LOT 32 - SUITE 500

6112 43rd STREET

REVISIONS: 11/17/2008

EXHIBIT "C-1"

SANITARY SEWER PLAN
SCALE: 1/8" = 1'-0"

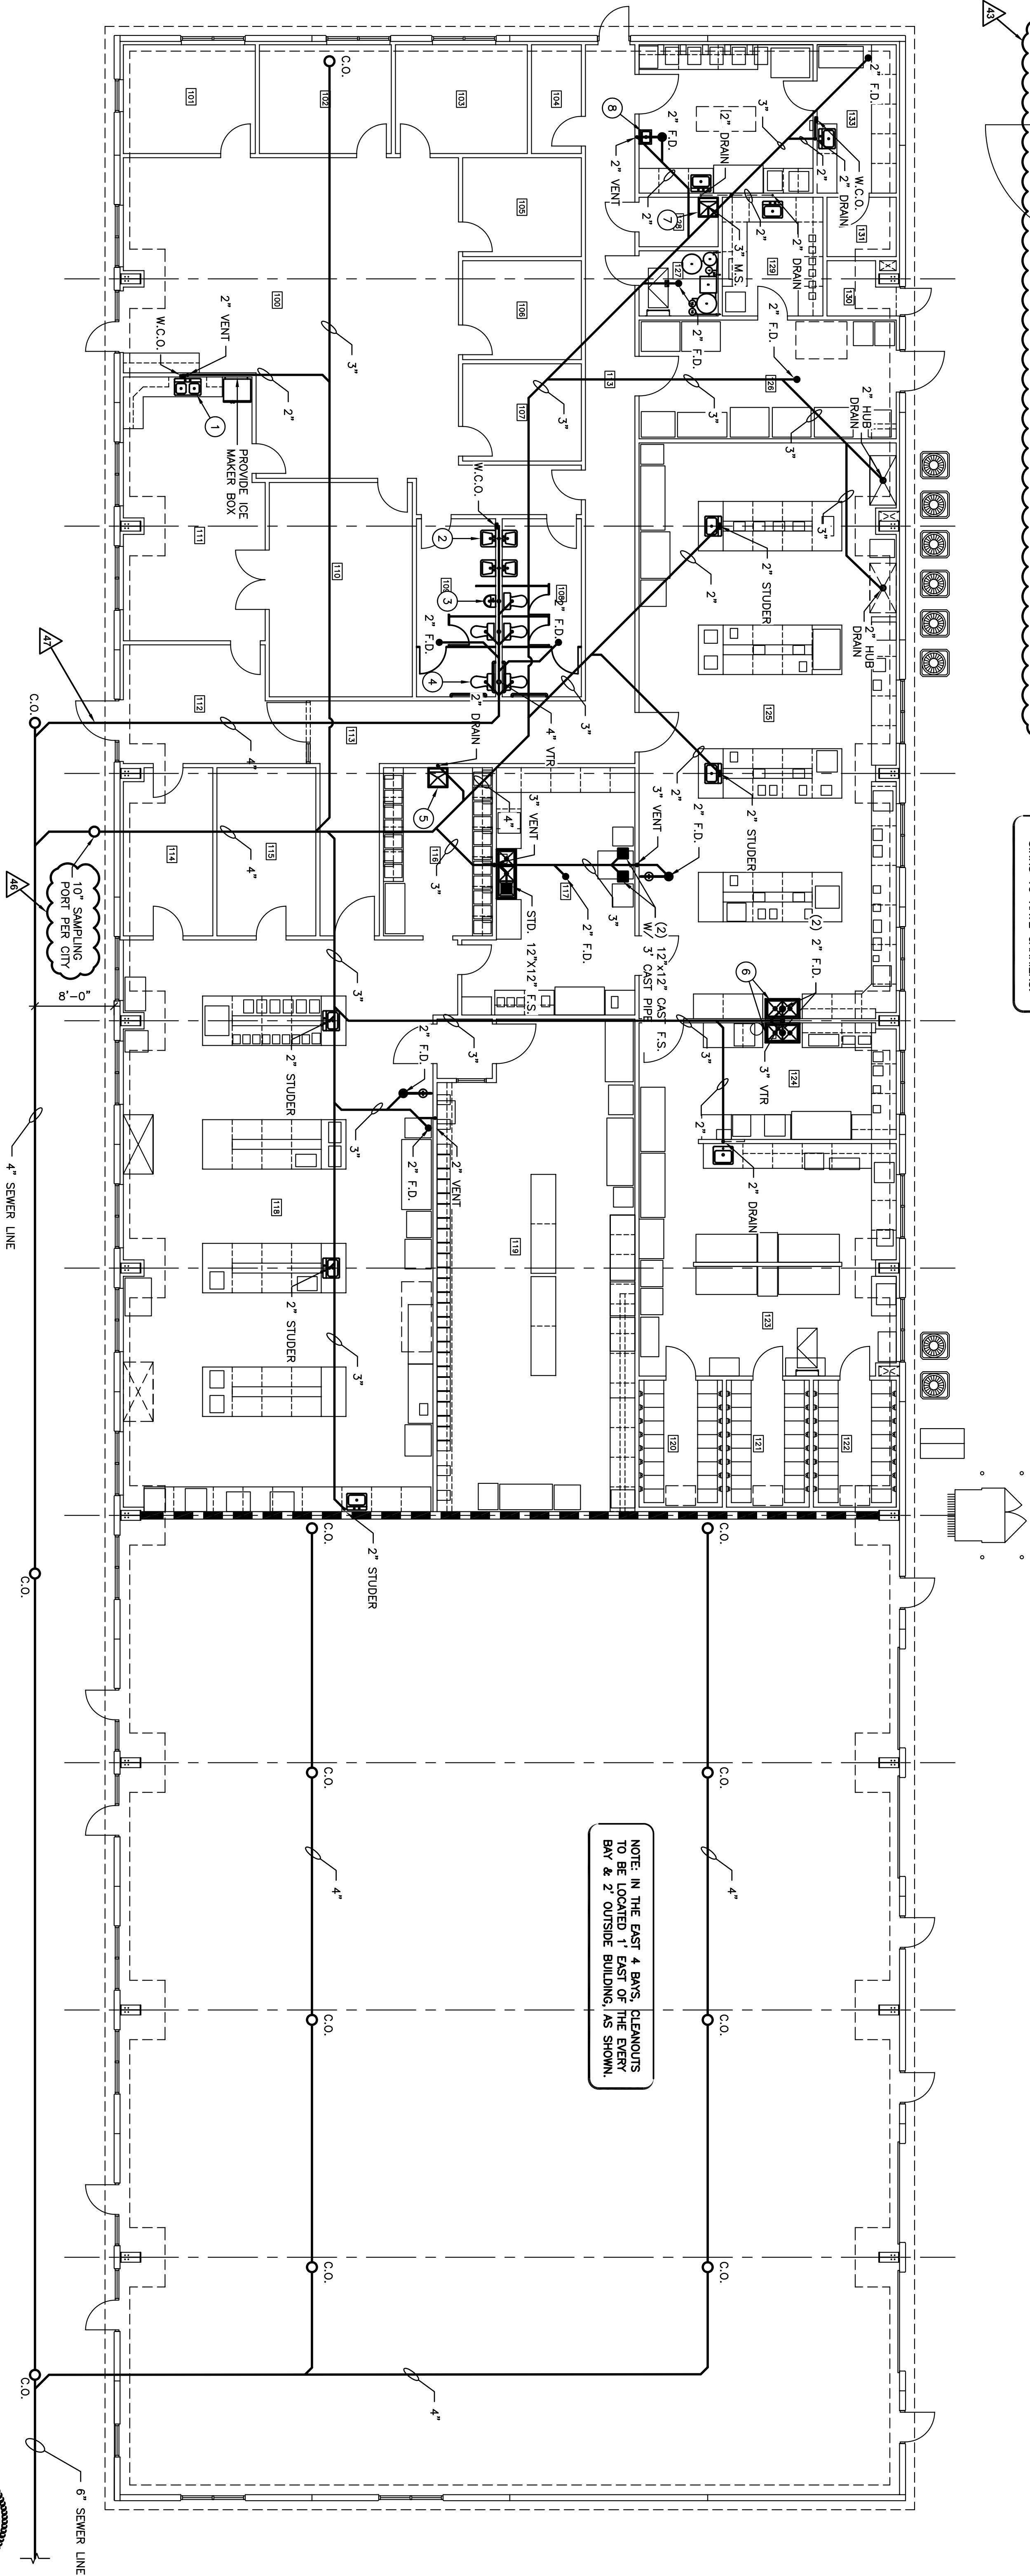
ADDED 10" SAMPLING PORT AS PER CITY OF LUBBOCK, SEE SHT. P1.
- 47

SEPARATED BATHROOM SEWER LINES FROM REST OF BUILDING FOR SAMPLING PORT SEE SHT. P1.
- 48
